<https://www.thingiverse.com/thing:4228123>

Different Versions of 3D printed face mask

rev3.5 changes:

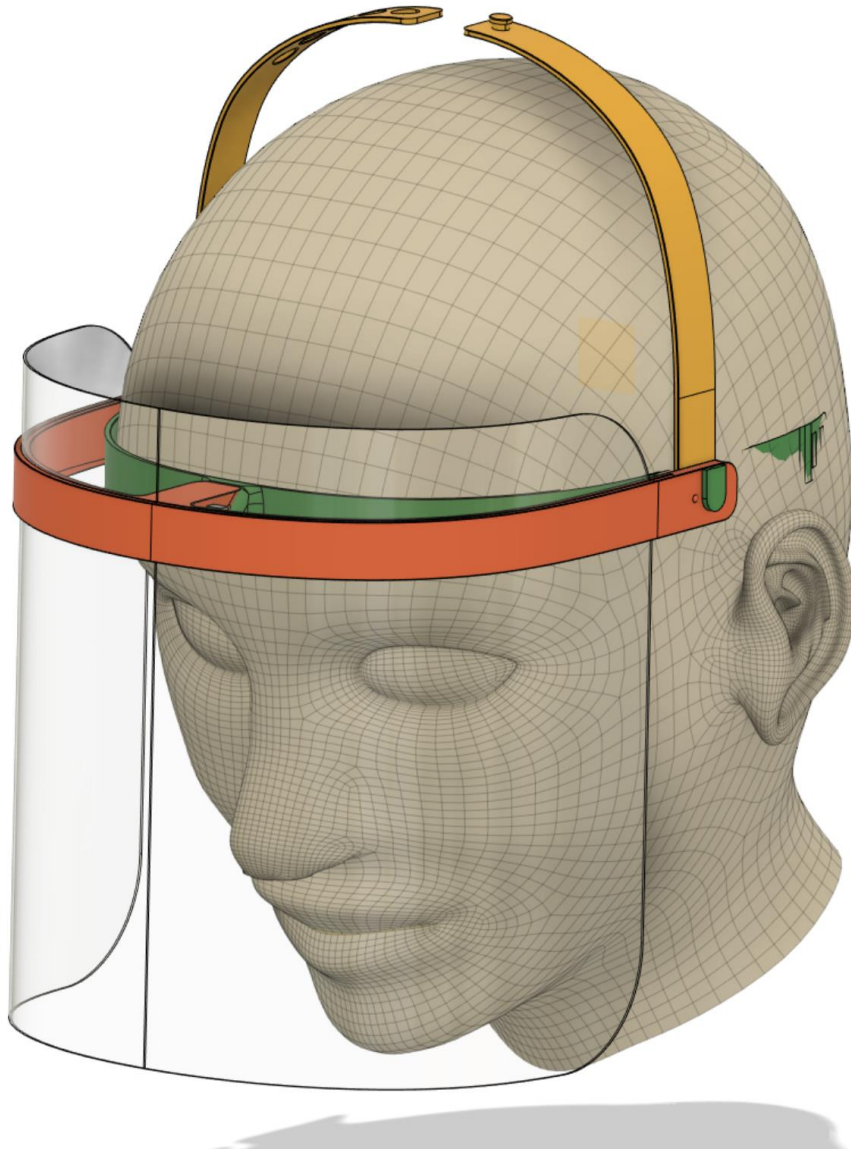
1. Increased distance to face
2. 2° inclination of the sheet
3. Stronger fixation for strap
4. Small adjustments for the upper printed strap
5. Adjusted total dimensions for smaller printers <190x190mm
6. Slot enlarged for horizontal A4 installation

rev3.5.1 changes:

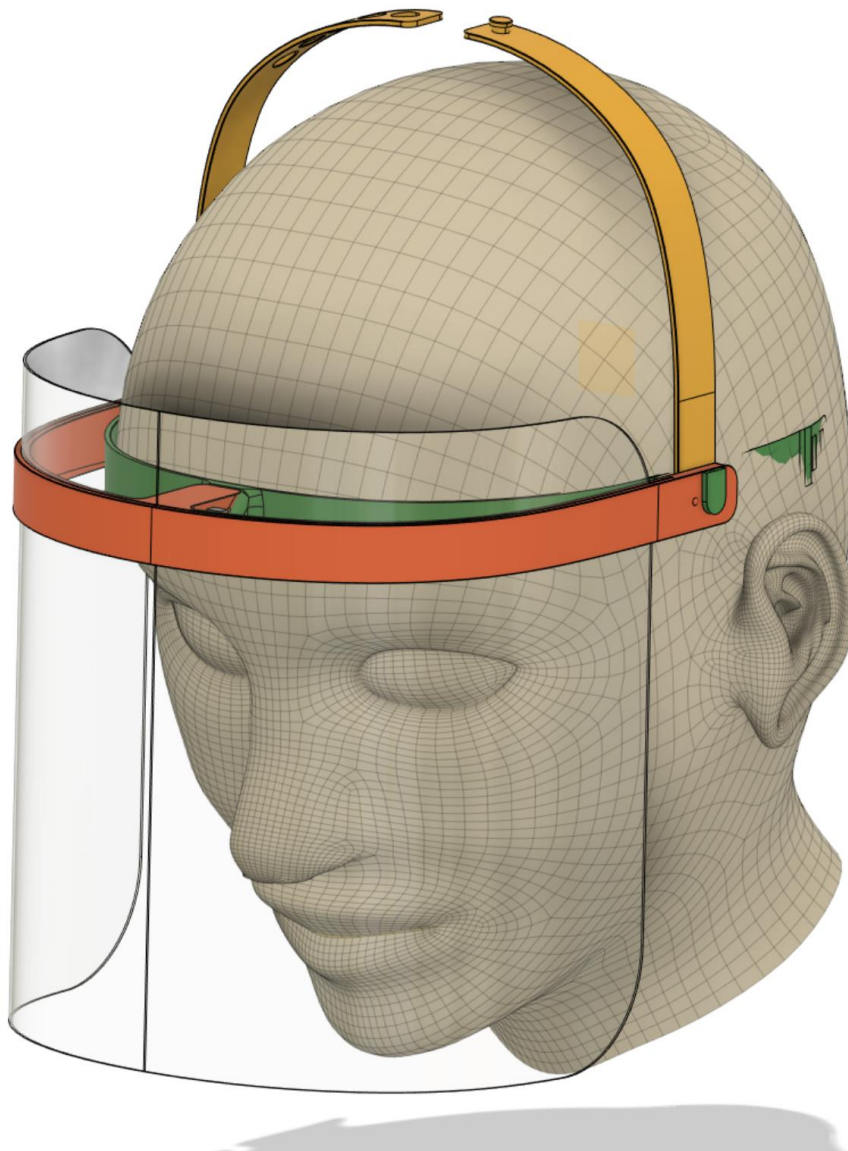
1. improved slot system top strap
2. added M3 screw and nut for A4 sheet fixation

rev3.5.1b (optional change)

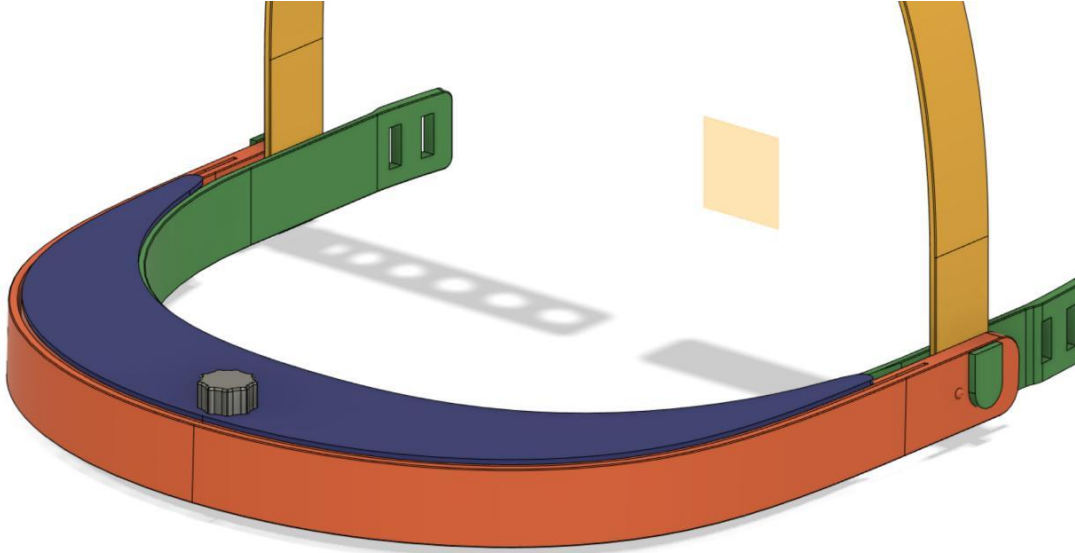
1. Shorter version, may be possible to fit 2 on 235x235 bed like ender 3.

rev 3.6 changes:

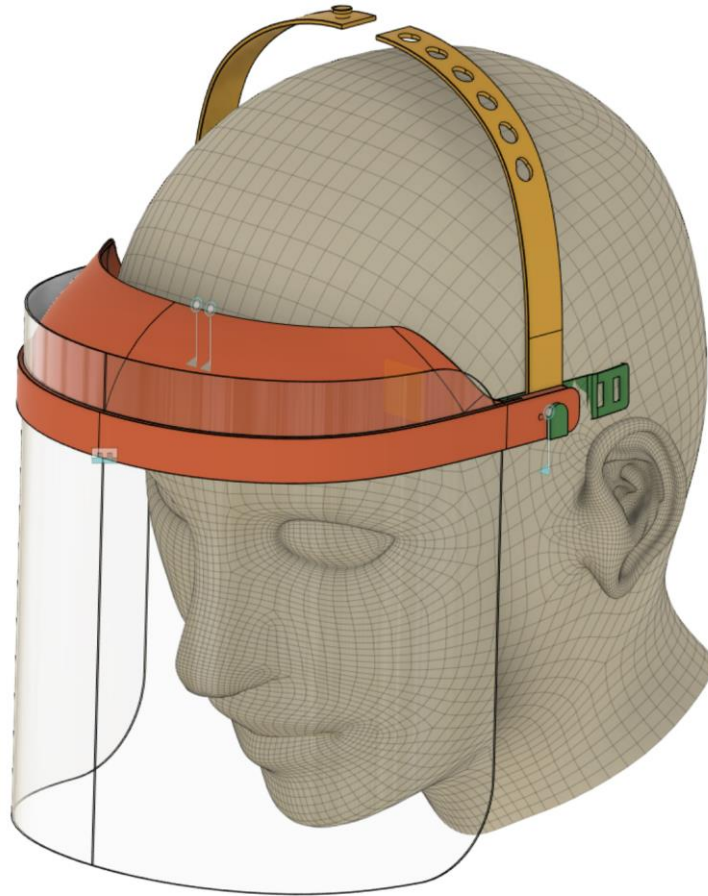
1. Changed lid design, only 1 file. No assembly needed.
